Franklin County Planning Commission

Wednesday, October 14, 2015
1:30 pm

STAFF REPORT

Case 667-FP(b)

JEFFERSON TOWNSHIP, FRANKLIN COUNTY, OHIO
 DEVELOPMENT PLAN
 FOR
WELDON
 SITE PLAN

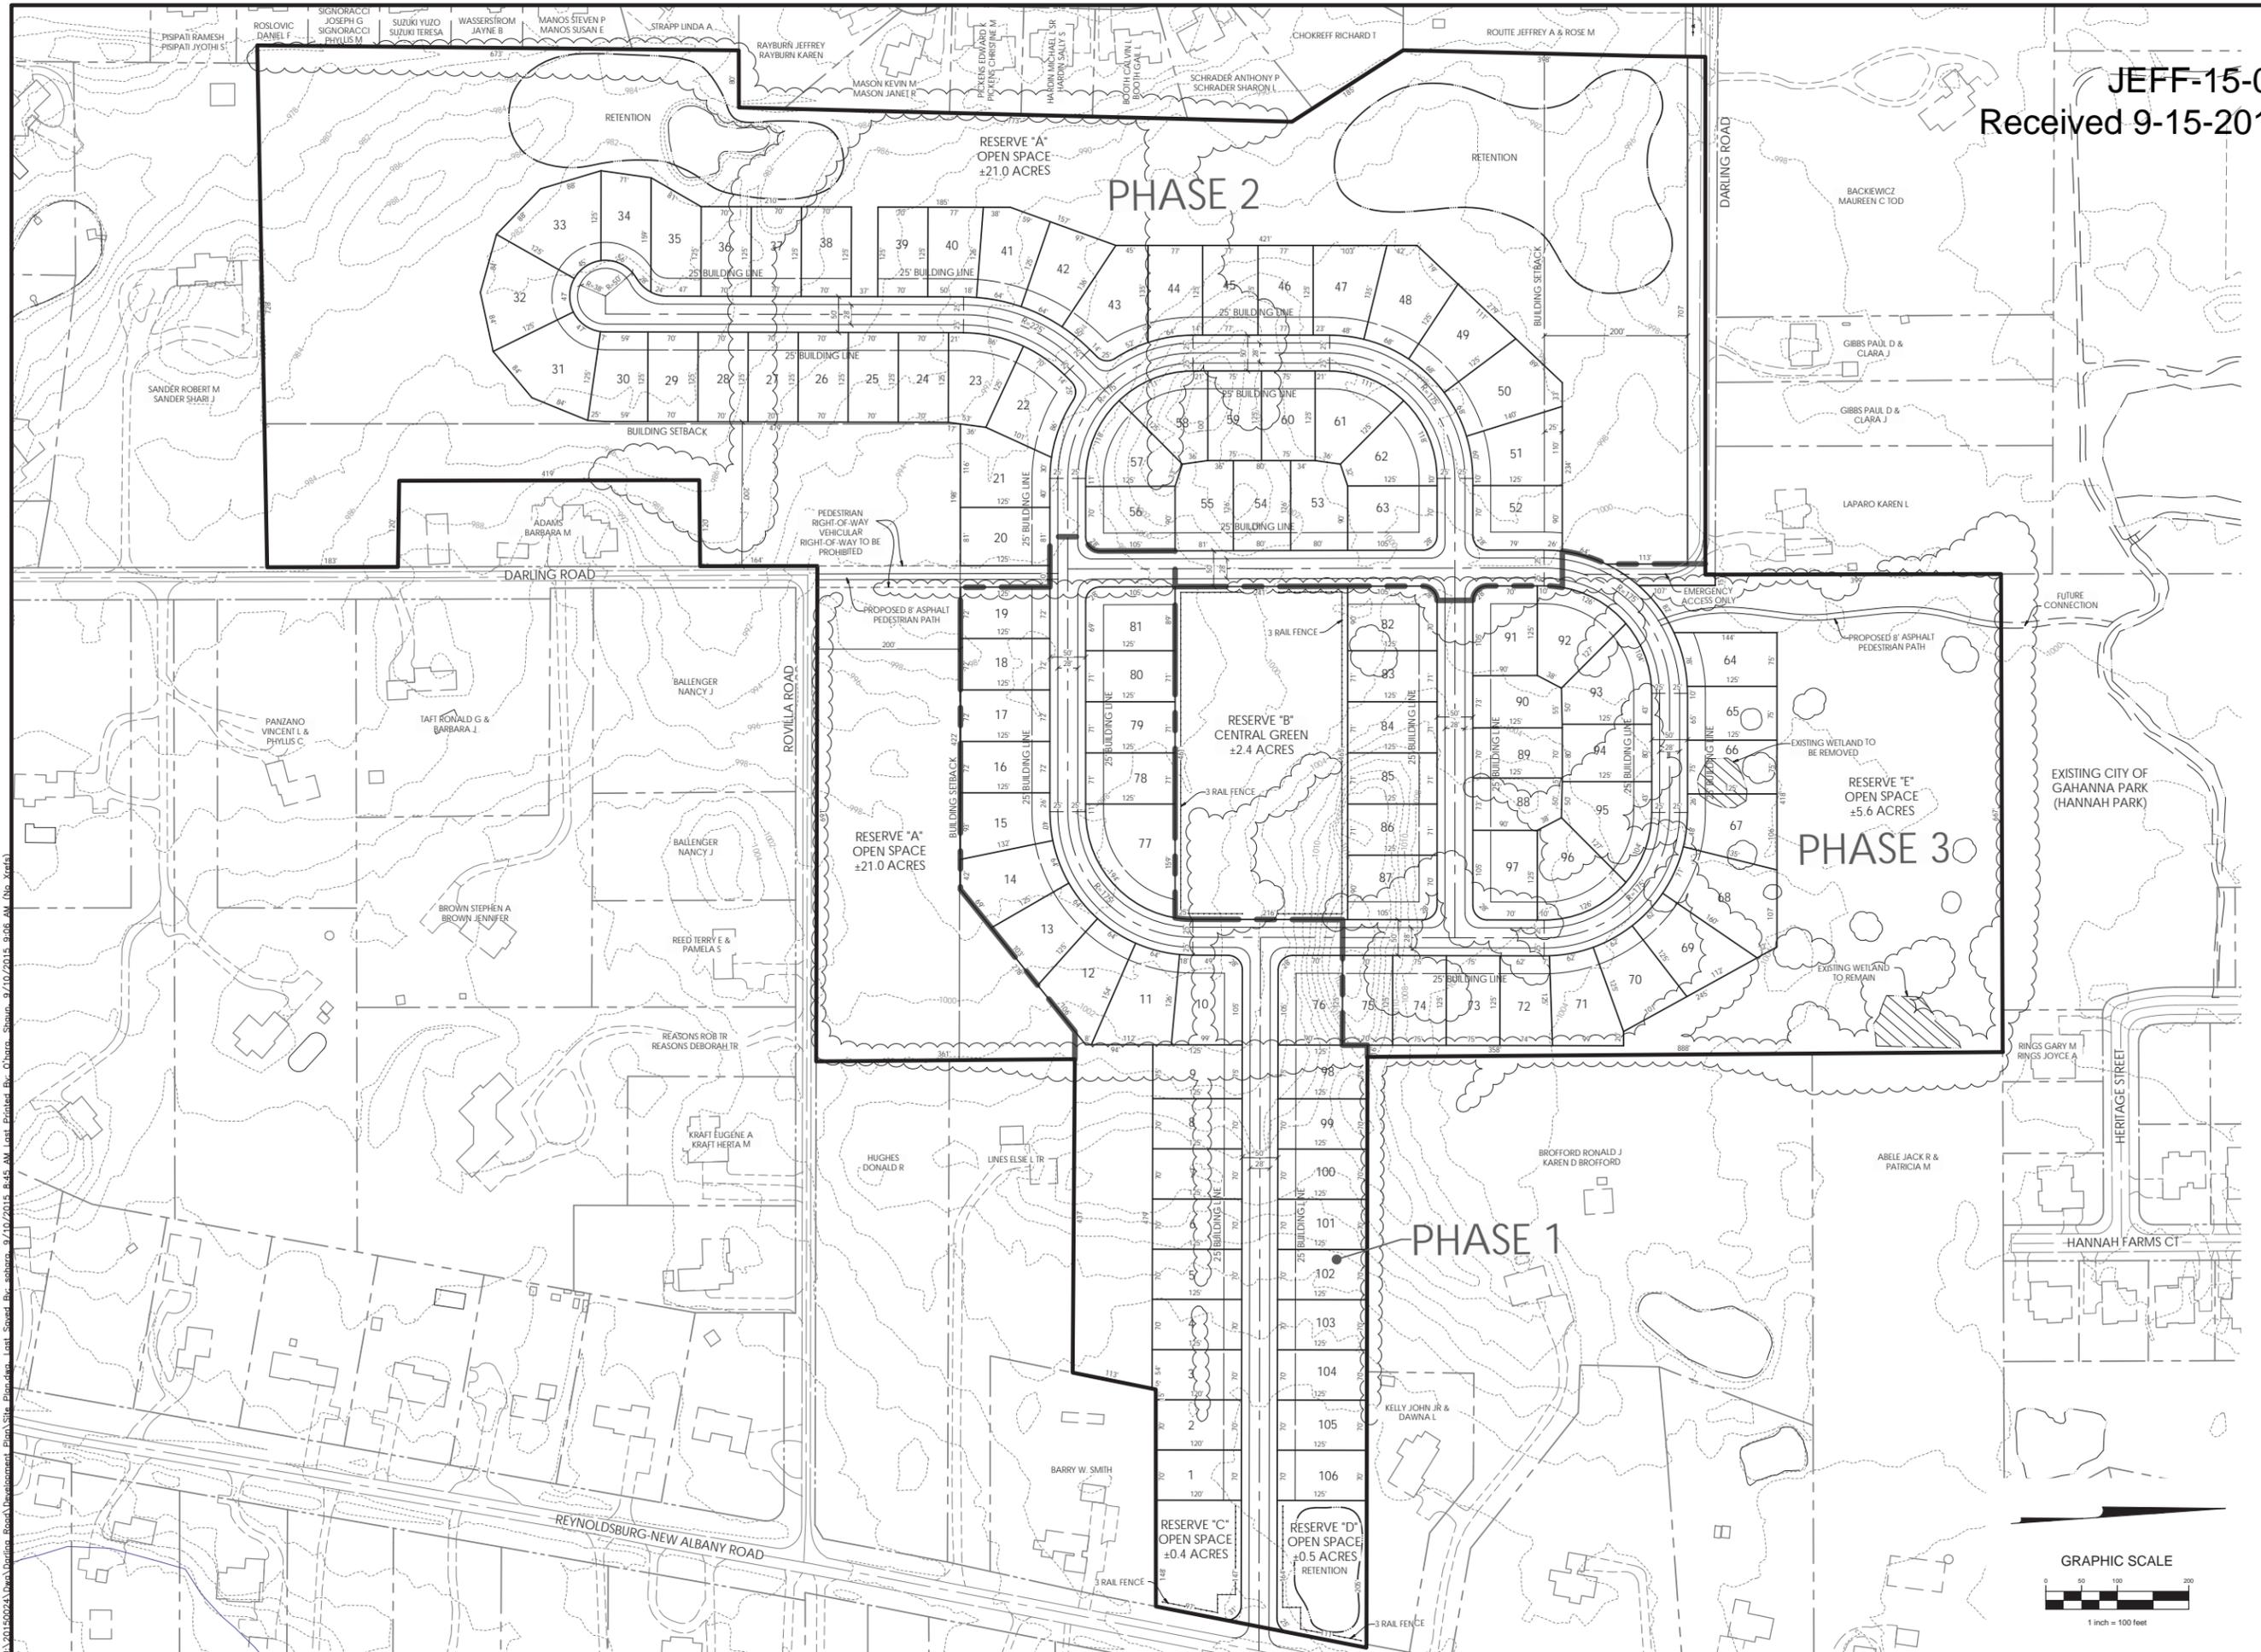
- The boundary between Phases 2 and 3 should be revised to include the emergency access in Phase 2.
- All existing wells and septic systems need to be properly abandoned to the satisfaction of Franklin County Public Health.

- It should be considered to shift the proposed pedestrian path in Phase 3 and lots 64-67 to avoid the proposed wetland disturbance.
- The development plan does not provide for the recommended building setback of 250 feet from Scenic Byways.

- Numerous lots in the proposed development are located in soils identified as being poorly drained. The Franklin County Subdivision Regulations prohibits the construction of basements in these soils. A note identifying lots impacted by these soils must be included on the Preliminary Plan.

- No details are provided for the landscape buffer shown in Reserve “E”
- The list of permitted uses should be revised to include only those uses that would be appropriate for the lot sizes proposed.

- Sidewalks should be 5 feet in width
- The rear yard setback should be revised to be 20% of the lot depth as opposed to the 25 feet proposed.
- Fencing should be used along the rear of lots abutting open space as opposed to the proposed bollards.

- The construction timeframe should be revised to account for the necessary subdivision plan approvals
